Special Exception Request S-786-B, McDonald's

Completed: December 22, 2011
UPDATED: January 12, 2012

- 2207 Bel Pre Road, Silver Spring
- C-1, 1994 Aspen Hill Master Plan
- Approx 26,679 s.f. of area
- Modification of an existing special exception for a drive-in restaurant on the property to allow for construction of a new building, reconfiguration of existing drive-through lanes and establishment of new one-way drive aisle.

SITE PLAN

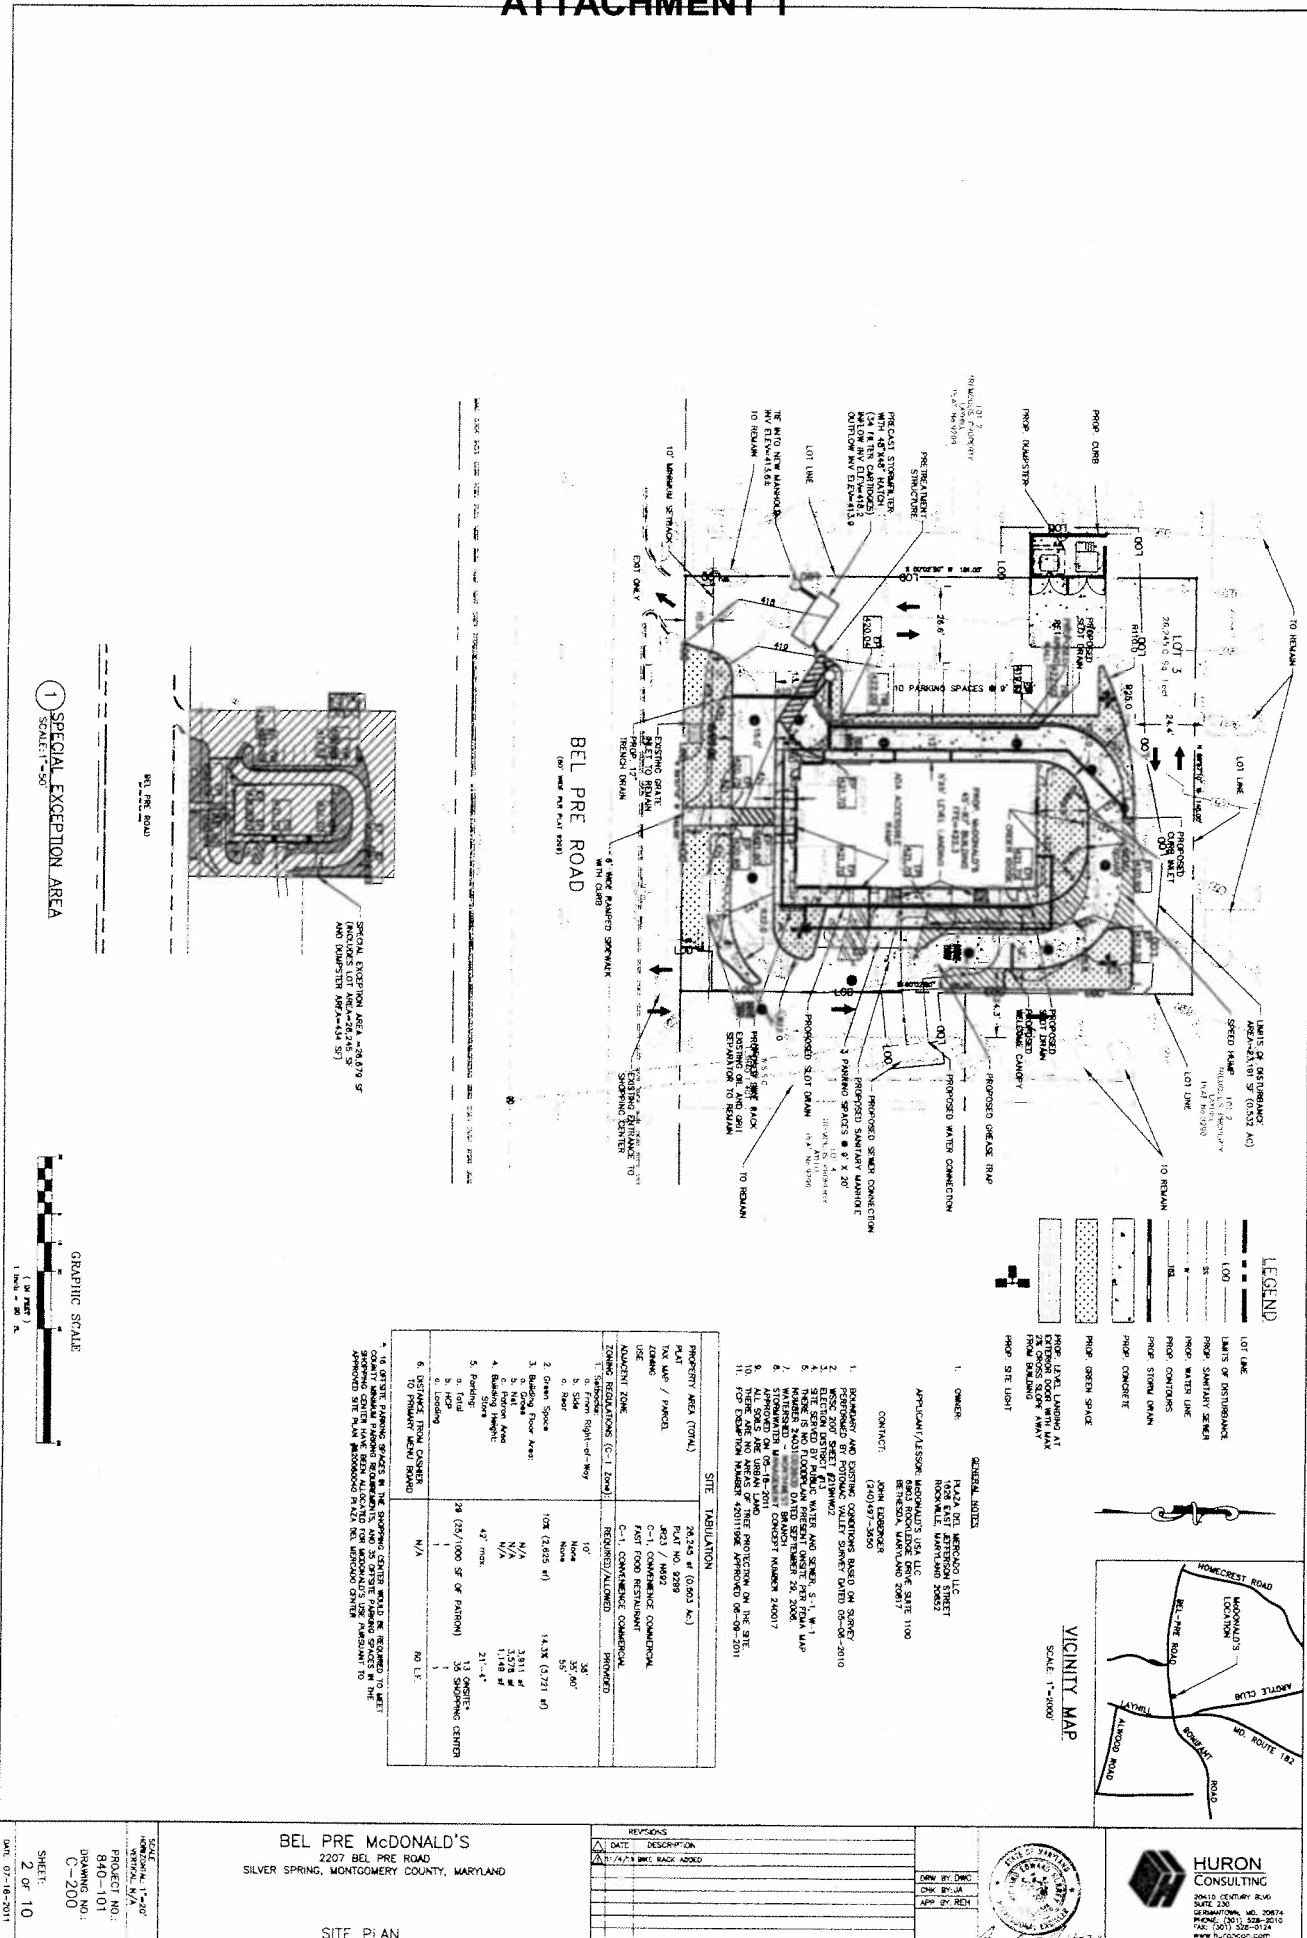
3. The project must provide a handicapped ramp on the south side of the building, leading into the pedestrian crossing, which crosses the drive-through exit.

4. The project must provide a pedestrian refuge at the end of the pedestrian crossing located on the southwest side of the drive-through lane's exit.
5. The project is subject to Site Plan review per §59-D-3 as required by § 59-C-4.341.2. The applicant must submit to the Board of Appeals any changes to the site, landscape and/or lighting plans stemming from the Site Plan review.

staff analysis: The proposed special exception does not meet the parking requirement of providing minimum 29 on-site spaces per Article 59-E. The application is proposing to provide thirteen on-site parking spaces on site and provide the remaining 16 spaces on the adjoining Plaza del Mercado shopping center site. are provided. However, tThe approved site plan (~~#820060040~~) for the Plaza del Mercado allocates 35 off-site parking spaces (~~#820060040~~) for this special exception. Therefore, adequate parking exists for the proposed modification. Staff is supportive of a parking waiver this agreement because the applicant and the owner of Plaza del Mercado have an agreement to allocate use 35 off-site spaces in the larger parking lot to McDonald's customers. In additionA. Although this is a single parcel, with a single use and structure, this site functions with the adjacent Plaza del Mercado, and site circulation and parking is addressed for both parcels.

The drive aisles are being re-aligned to improve site circulation. Currently, the drive aisles and parking areas are not separated from the drive-through, and there is no safe way to access the drive-through window if a patron is on the west side of the McDonalds site without having to go back onto Bel Pre Road. The revised circulation provides for a continuous, one-directional flow around the site, subject to the applicant providing a pedestrian refuge, as outlined in Condition 3. Additionally, with the proposed improvements to the drive ~~to on~~ the east side of the building of the site, fewer will prevent patrons are likely to from making a wrong turn down a "one-way only" drive aisle from the adjoining parking lot. The applicant is providing landscape islands around the site to define the drive-through, and allow for less discouragement queue jumping if one were coming from the north or west of the parcel.
